World Forum for Harmonization of Vehicle Regulations**Working Party on Passive Safety****Fifty-ninth session**

Geneva, 9-13 May 2016

Regulation No. 44 (Child restraint systems)**Proposal for Supplement 12 to the 04 series of amendments
to Regulation No. 44 (Child Restraint Systems)****Submitted by the expert from the European Association of Automotive
Suppliers***

Figure 1

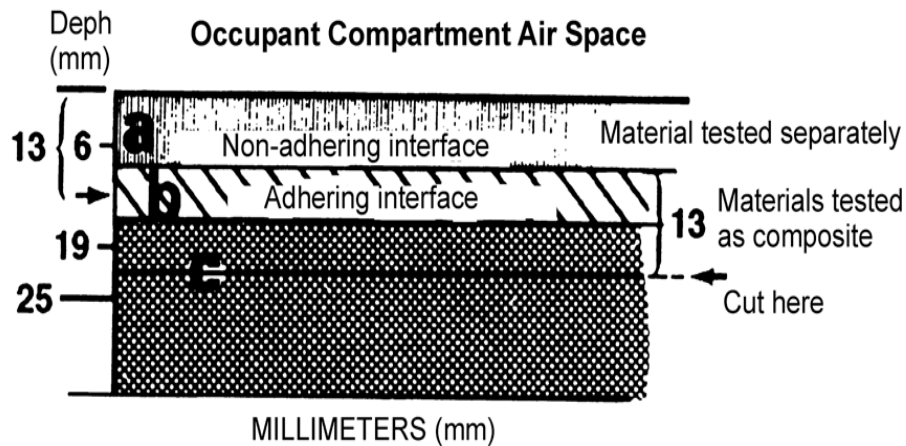
2. Material selection (see Figure 1 below)

2.1. Any portion of a single or composite material which is within 13 mm of the occupant compartment air space shall meet the requirements in Paragraph 6.1.6.

2.1.1. Any material that does not adhere to other material(s) at every point of contact shall meet the requirements of Paragraph 6.1.6. when tested separately

2.1.2. Any material that adheres to other materials at every point of contact shall meet the requirements of Paragraph 6.1.6. when tested as a composite with the other material(s).

Material A has a non-adhering interface with material B and is tested separately.

Part of material B is within 13 mm of the occupant compartment air space, and materials B and C adhere at every point of contact; therefore, B and C are tested as a composite.

The cut is in material C as shown in Figure 1, to make a specimen 13 mm thick.

Figure 2
All dimensions in millimeters (mm)

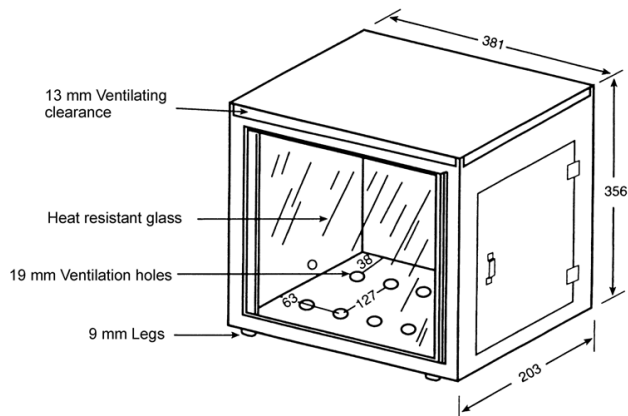
3.1 The test is conducted in a metal cabinet for protecting the test specimens from drafts. The interior of the cabinet is 381 mm long, 203 mm deep, and 356 mm high. It has a glass observation window in the front, a closable opening to permit insertion of the specimen holder, and a hole to accommodate tubing for a gas burner. For ventilation, it has a 13 mm clearance space around the top of the cabinet, ten holes in the base of the cabinet, each hole 19 mm in diameter and legs to elevate the bottom of the cabinet by 10 mm, all located as shown in Figure 2.

3.3. The test specimen is inserted between two matching U-shaped frames of metal stock 25 mm wide and 10 mm high.

The interior dimensions of the U-shaped frames are 51 mm wide by 330 mm long.

3.4. A bunsen burner with a tube of 10 mm inside diameter is used.

The gas adjusting valve is set to provide a flame, with the tube vertical, of 38 mm in height. The air inlet to the burner is closed.
